# 40 STATION APPROACH

SECTION 73 - PLANNING DRAWINGS AMENDMENTS

CONSENTED PLANNING DRAWINGS PLANNING REF. 27345/APP/2021/1291	SECTION 73 PROPOSED DRAWINGS
PROPOSED GROUND FLOOR PLAN	001_2000 REV.03	21002-STY-00-DR-A-P01-100-A
PROPOSED FIRST FLOOR PLAN	001_2001 RE.02	21002-STY-01-DR-A-P01-101-A
PROPOSED SECOND FLOOR PLAN	001_2002 REV.02	21002-STY-02-DR-A-P01-102-A
PROPOSED ROOF PLAN	001_2003 REV. 02	21002-STY-03-DR-A-P01-103-A
PROPOSED SITE PLAN	001_2005 REV. 03	21002-STY-00-DR-A-P00-001-A
PROPOSED SITE CONTEXT PLAN	001_2006 REV. 02	21002-STY-00-DR-A-P00-002-A
PROPOSED NORTH ELEVATION	001_2020 REV. 03	21002-STY-ZZ-DR-A-P03-301-A
PROPOSED WEST ELEVATION	001_2021 REV. 04	21002-STY-ZZ-DR-A-P03-302-A
PROPOSED SOUTH ELEVATION	001_2022 REV. 03	21002-STY-ZZ-DR-A-P03-303-A
PROPOSED EAST ELEVATION	001_2023 REV. 03	21002-STY-ZZ-DR-A-P03-304-A
PROPOSED STREET SCENES	001_2030 REV. 03	21002-STY-ZZ-DR-A-P03-300-A
PROPOSED STREET SECTIONS	001_2031 REV. 03	21002-STY-ZZ-DR-A-P02-200-A

Approved Planning Drawing  
001\_2000 Rev. 03\_Proposed Ground Floor Plan

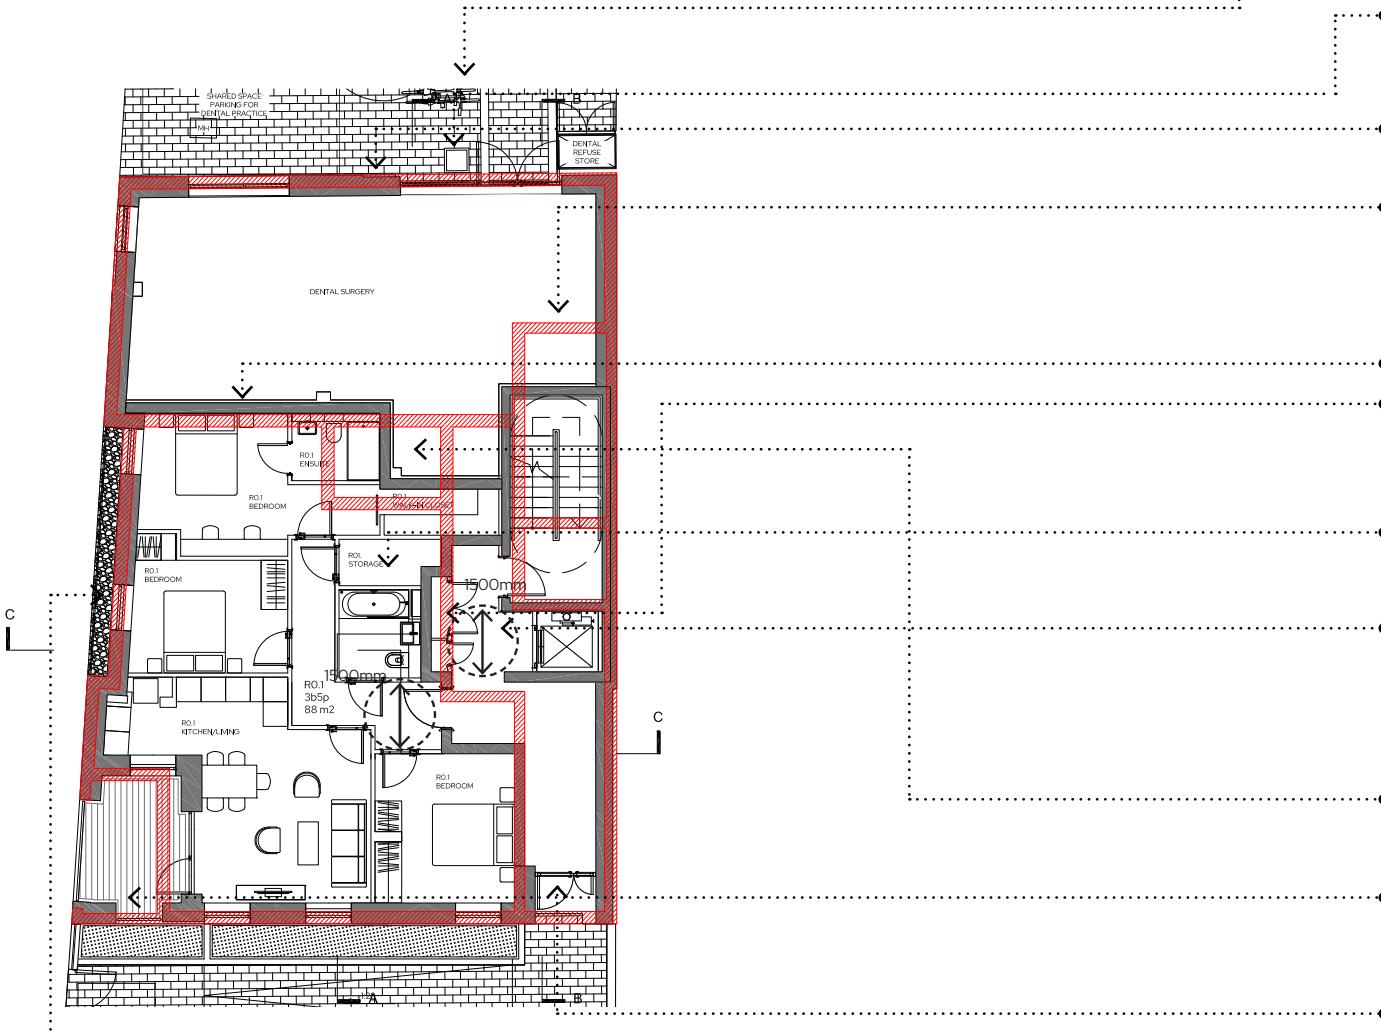
- Non fire-fighting stair: 900mm (between handrails)
- Fire-fighting stair: 1100mm (between walls/ balustrade).

- A clear landing, a minimum of 1500mm long x 1500mm wide, needs to be provided directly in front of the lift door at **every floor level**.

#### Part B - Open plan layouts require sprinkler systems.

- If sprinkler systems are not intended then the layout cannot be open plan as cooking facilities need to be remote from the main entrance door and do not impede the escape route from anywhere in the flat.

- Canopy covering a minimum of width and depth of 1200 x 900mm for M4(2).
- Clear turning circle 1500mm in diameter inside the entrance area behind the entrance door.

- Minimum 1500mm diameter clear turning circle behind closed front door of flat.

- Risers within the bathroom/cloakroom have not been included and the bathrooms and kitchens are not stacked.
- The size and requirement of the plant room had not been assessed by an M&E consultant.

## 1.1.2 OVERLAY WITH APPROVED PLANNING DRAWINGS

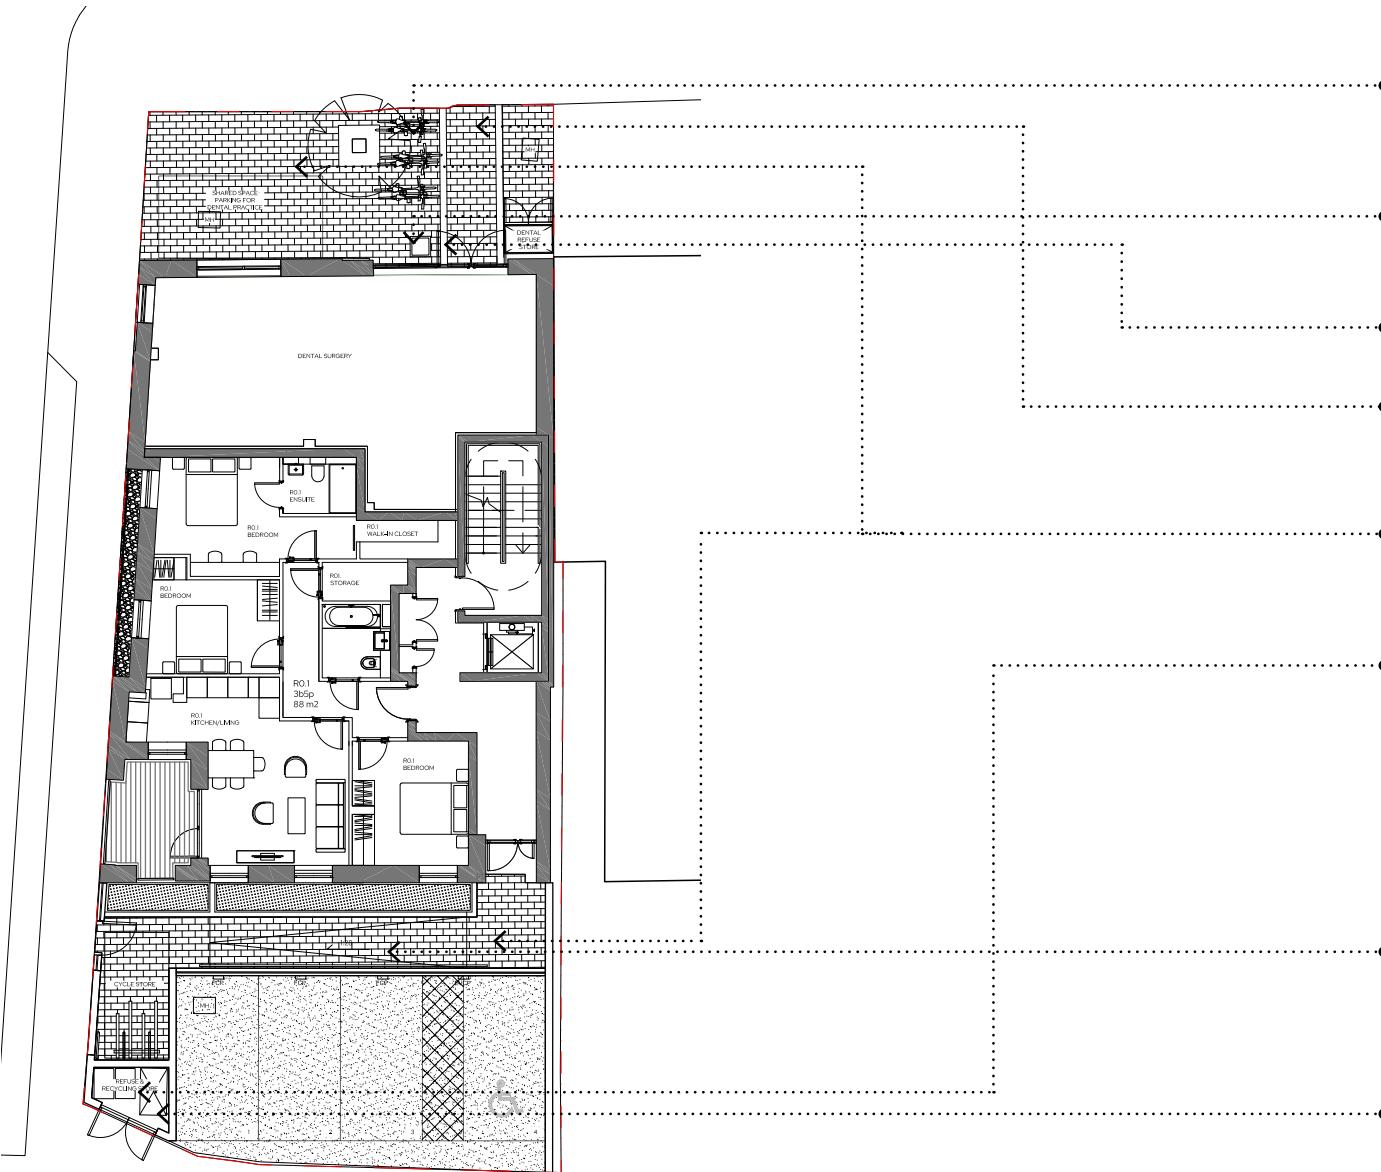
Cycle storage relocated west of dental practice entrance to allow sufficient space for when stands are in use and for access and use of dental waste bin.

Free standing planter added outside dental practice door to prevent door opening onto pedestrians.

External wall thickness increased from 300mm to 508 mm to meet NBHC and Part B standards

Staircase and lift had to shift further south so flats on the upper floor can meet minimum space standards. Staircase increased in width and length to comply with Part K.

Party wall shifted to allow stacking with wall above.

Risers in the communal area and flats have previously not been included. These have been added and stacked.

Minimum in-built storage space requirements included.

Circle indicates 1500mm x 1500mm space required in front of lift doors on all floors.

Flat layout revised to provide protected routes out in the event of a fire without the need of sprinklers.

Plant room not required. Space added in parts to the dental surgery and the 3 bedroom flat to comply with minimum space standards.

Balcony was previously 6 sqm. Needed to be increased to 8 sqm to meet minimum space standards for 3b5p.

Entrance door shifted inwards to avoid adding a 'clip on' canopy which would change the design of the scheme.

Replacing the raised planter with gravel and balustrade. This is due to maintenance and security reasons.

## 1.1.3 PROPOSED LANDSCAPE CHANGES

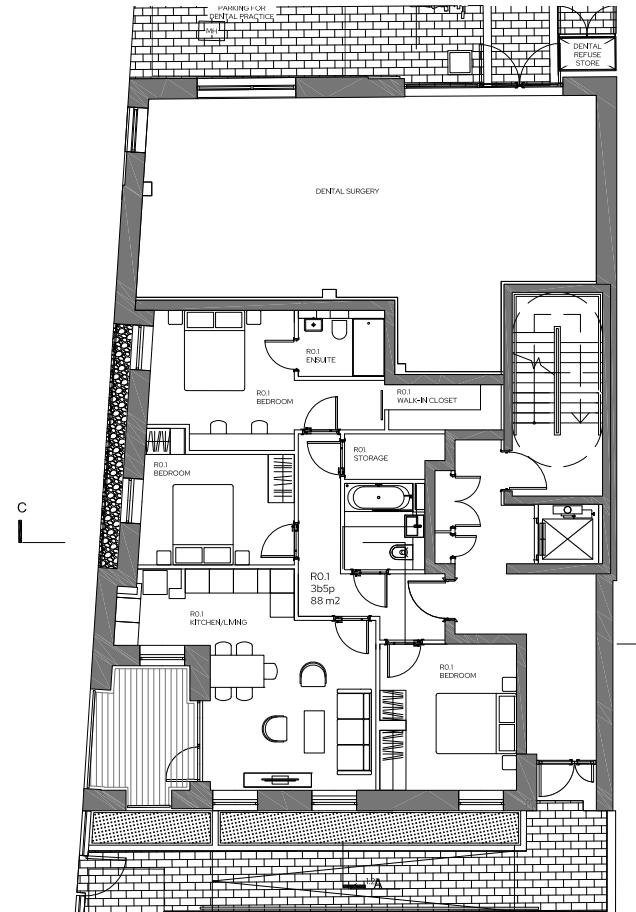
Cycle storage relocated west of dental practice entrance to allow sufficient space for when stands are in use and for access and use of dental waste bin.

Free standing planter added outside dental practice door to prevent door opening onto pedestrians.

Subtle paving band introduced to demarcate pedestrian entrance of dental practice.

Paving and surface finishes to front and rear areas clarified based on hierarchy of use. Block paving to frontage with a mix of sizes to delineate use and tarmac/concrete used for 'back of house' areas. Block paving has been selected for its suitability for lightly trafficked areas (car parking and wheelie bin use).

Residential bin and cycle stores are shown with a sedum roof (2990-LA-02). The introduction of the sedum roof is in compensation for its removal from the roof above the residential corridor which would have been very difficult to maintain.

Lighting bollards included to ensure sufficient levels of lighting for escape routes and amenity.

Ramp to residential access revised to have a shallower gradient, therefore forming a slope and improving the approach route.

Residential cycle store walls increased in height to allow for double stacking product and a roof (roof not allowed for in consented scheme). A wall has also replaced a section of railing to provide more security to the cycle store and consistency of the elevation with the main building. The increase in height is from circa 2.3m at bin store to 3m.

Approved Planning Drawing  
001\_2001 Rev. 02\_Proposed First Floor Plan

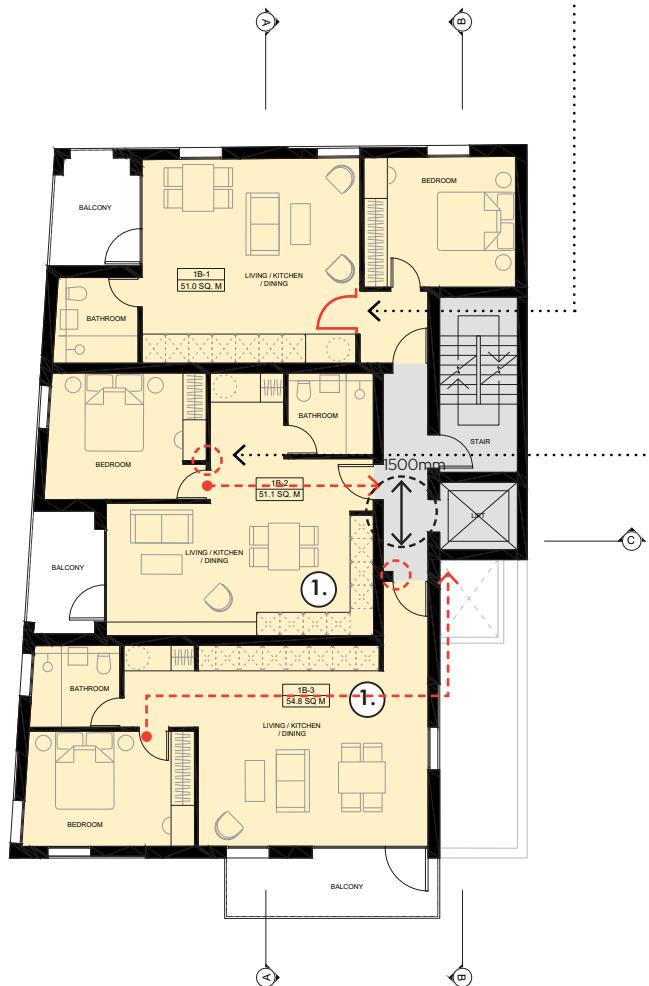
- Kitchen to be separate from bedroom escape route.

Inner Rooms - A room whose only escape route is through another room is termed an inner room. Such an arrangement is only acceptable where the inner room is a kitchen, a laundry or utility room, a dressing room, a bathroom/WC/shower room.

Typically open plan flat layouts are only acceptable when the building is sprinklered. An alternative solution could be a water misting fire suppression system. If a water misting system is deemed unacceptable then the layout will need to include a safe corridor to the flat entrance.

A minimum 300mm nib is provided to the leading edge of the door and the extra width created by the nib is maintained for a min. distance of 1200mm beyond it.

- Risers within the bathroom/cloakroom have not been included and the bathrooms and kitchens are not stacked.
- Minimum space standards in bedrooms need to be taken into consideration to meet PartM4(2).

- A clear landing, a minimum of 1500mm long x 1500mm wide, needs to be provided directly in front of the lift door at **every floor level**.

## 1.2.2 OVERLAY WITH APPROVED PLANNING DRAWINGS

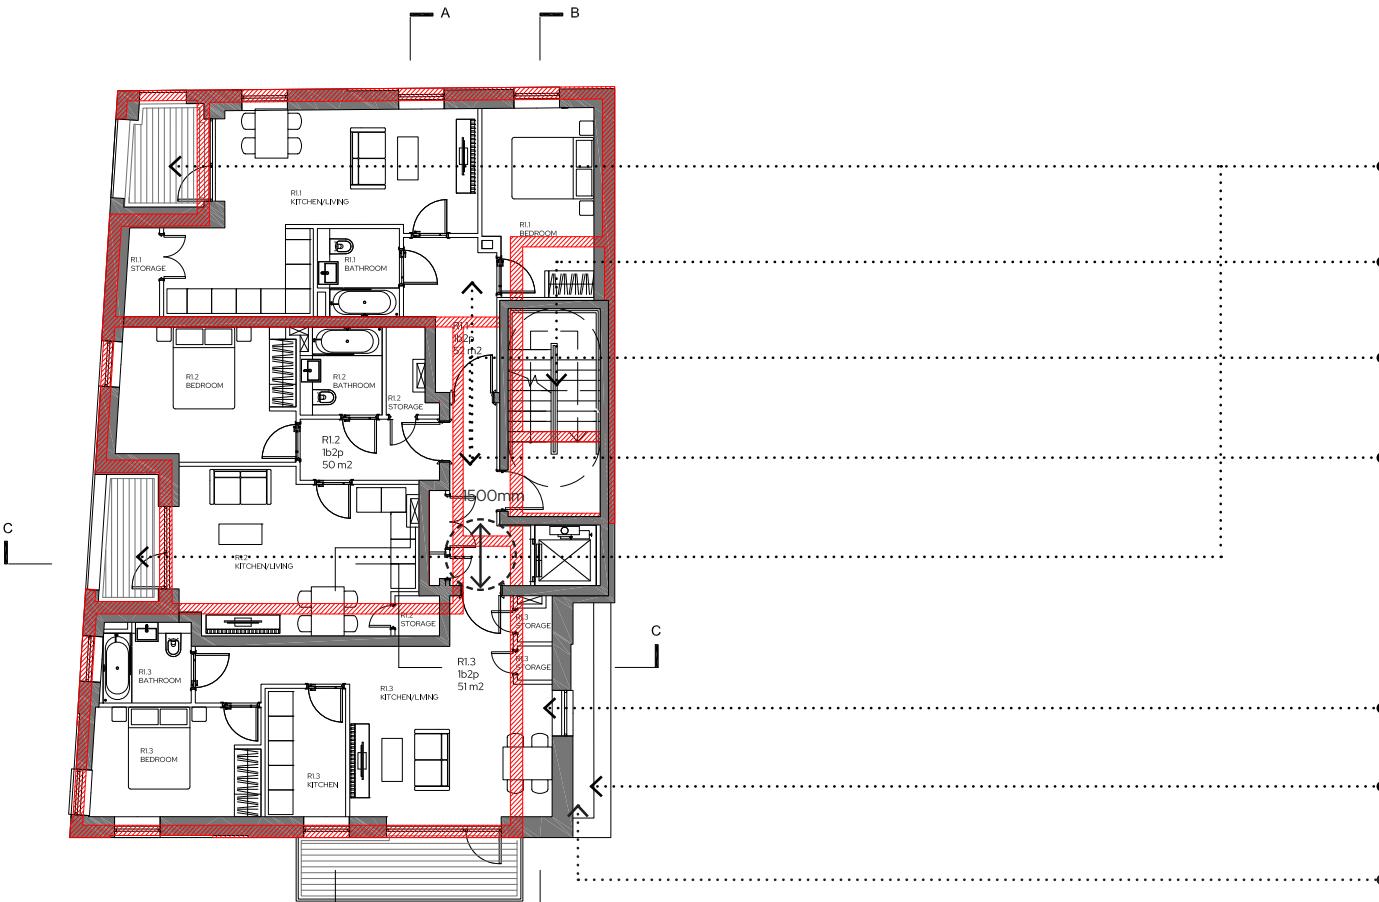
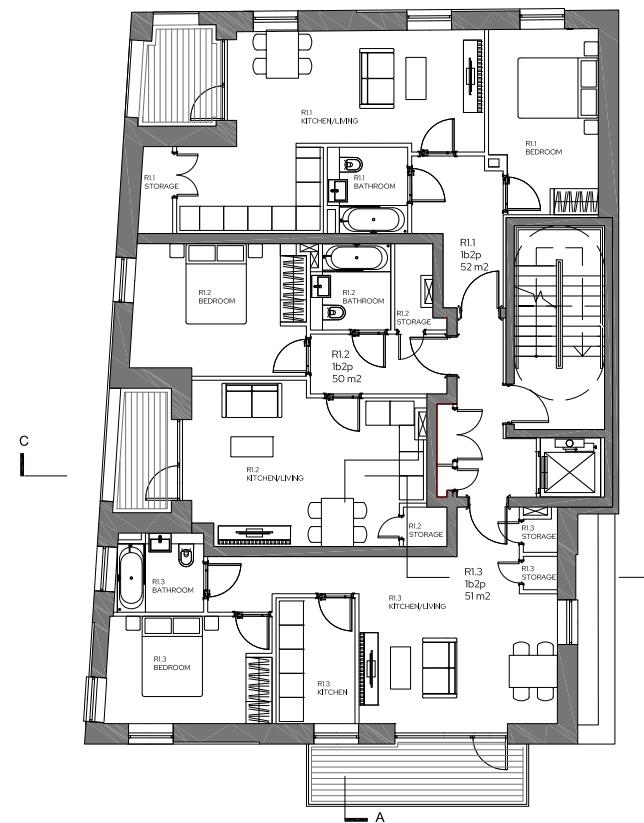
External wall thickness increased from 300mm to 508 mm to meet NBHC and Part B standards.

To comply with minimum space standards the core has to shift to the south and the building slightly increased to the east so that every 1 bedroom flat has a minimum NIA of 50 sqm.

Balcony sizes increased to meet minimum space standards.

Staircase increased in width and length to comply with Part K.

Circle indicates 1500mm x 1500mm space required in front of lift doors on all floors.

Protected corridors in all flats as open plan layouts are only possible with a mist or sprinkler system.

Minimum storage space requirements included.

Risers in the communal area and the flats have previously not been included. These have been added and stacked.

Massing of the building has increased in order to comply with minimum space standards for each flat.

Roof light and sedum roof above the communal corridor removed as the building has to increase.

Sedum roof replaced with pebble roof at lower level above residential entrance as maintenance access is restricted.

## 1.3.1 BUILDING REGULATIONS

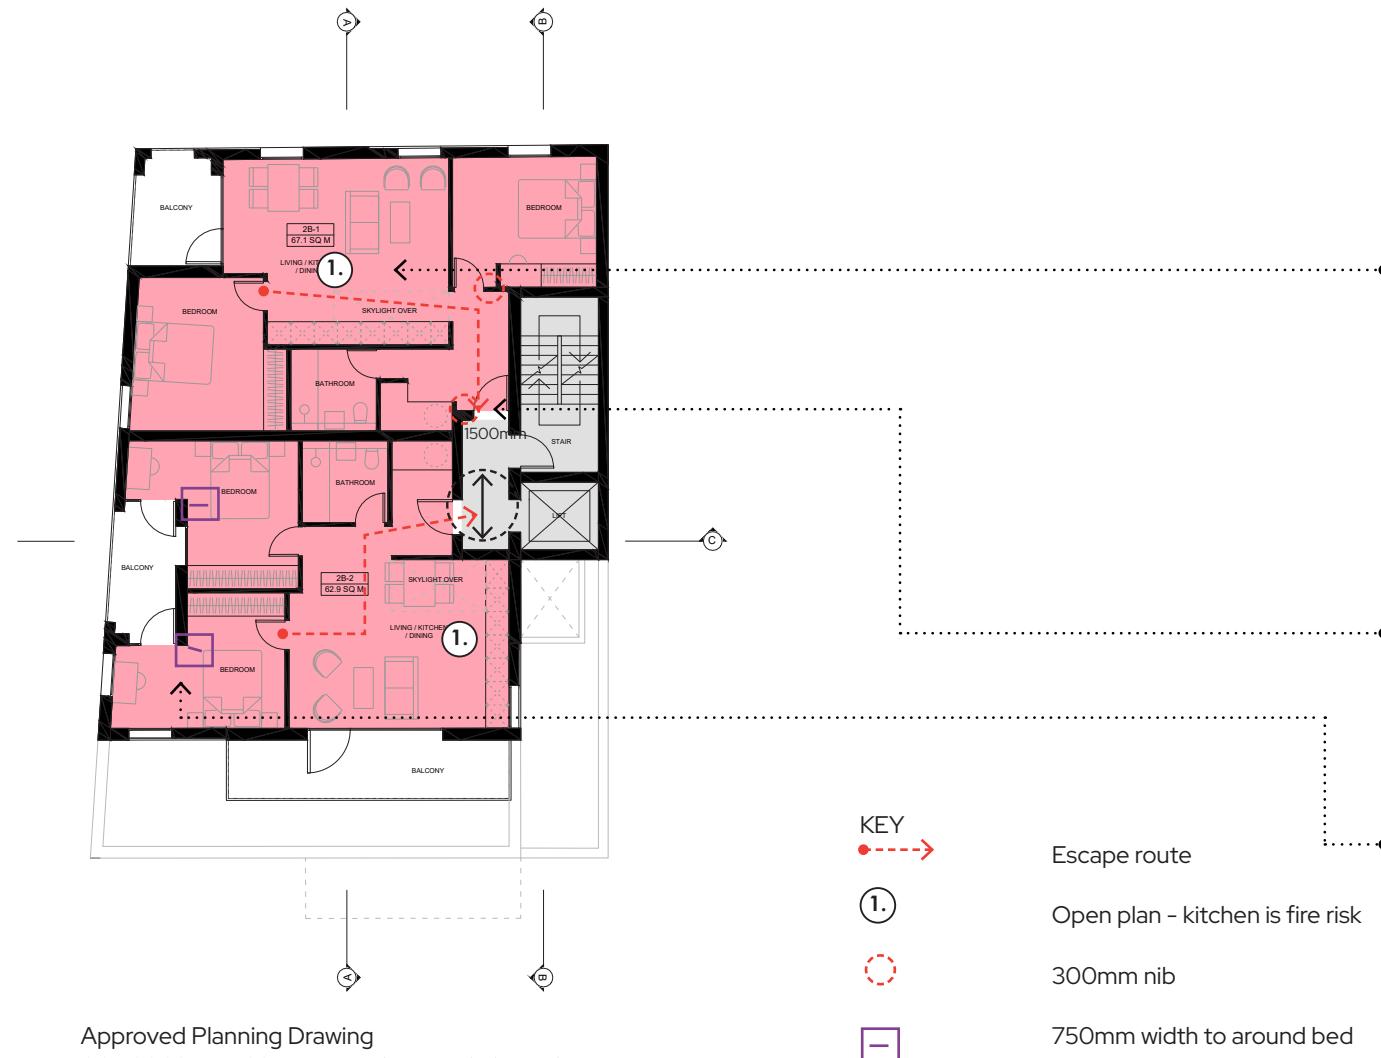
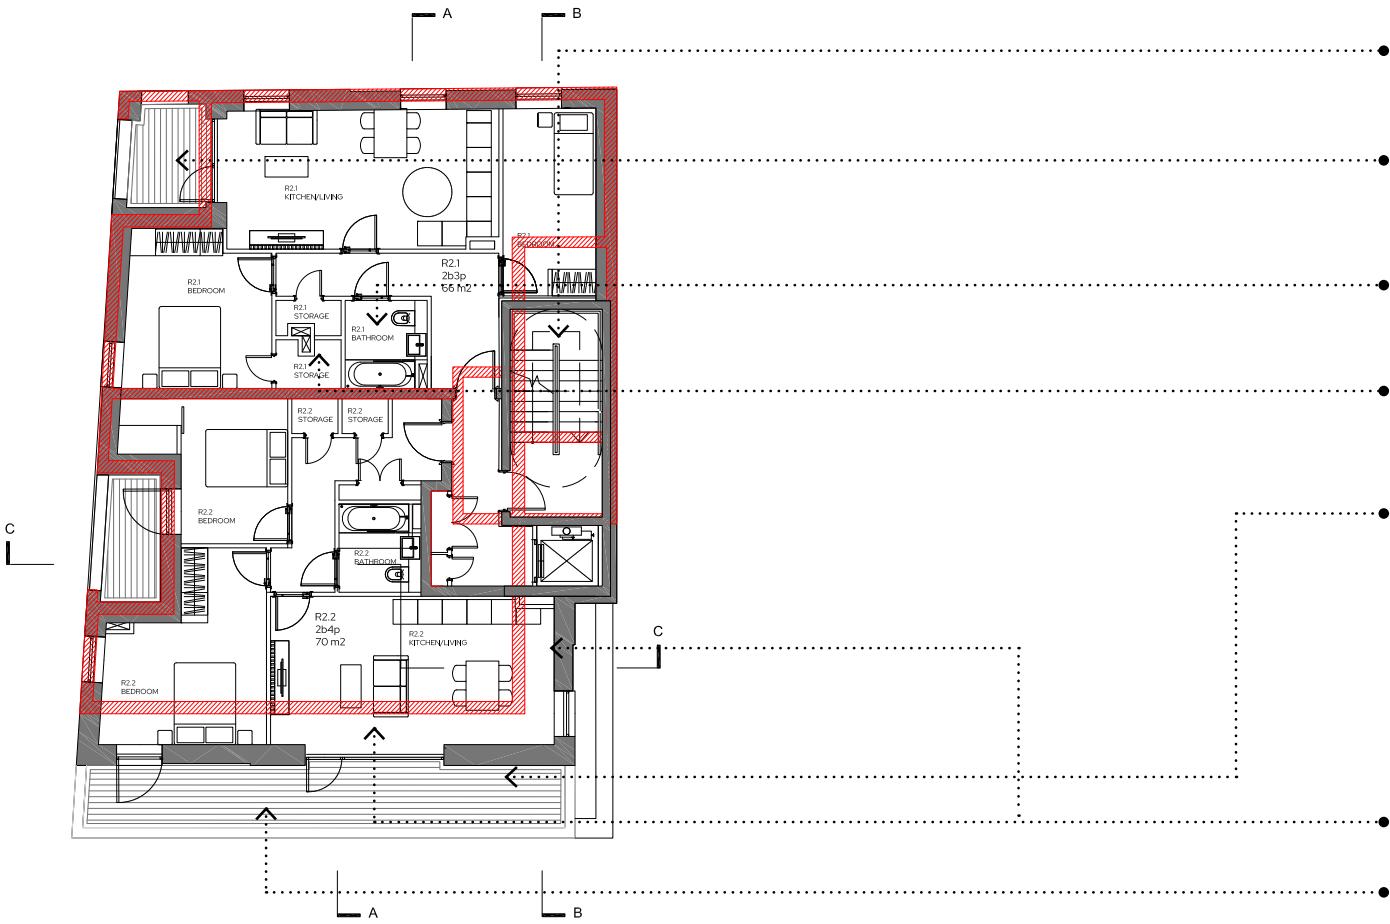
Typically open plan flat layouts are only acceptable when the building is sprinklered. An alternative solution could be a water misting fire suppression system. If a water misting system is deemed unacceptable then the layout will need to include a safe corridor to the flat entrance.

A minimum 300mm nib is provided to the leading edge of the door and the extra width created by the nib is maintained for a min. distance of 1200mm beyond it.

- Risers within the bathroom/cloakroom have not been included and the bathrooms and kitchens are not stacked.
- Minimum space standards in bedrooms need to be taken into consideration to meet PartM4(2).

- A clear landing, a minimum of 1500mm long x 1500mm wide, needs to be provided directly in front of the lift door at **every floor level**.
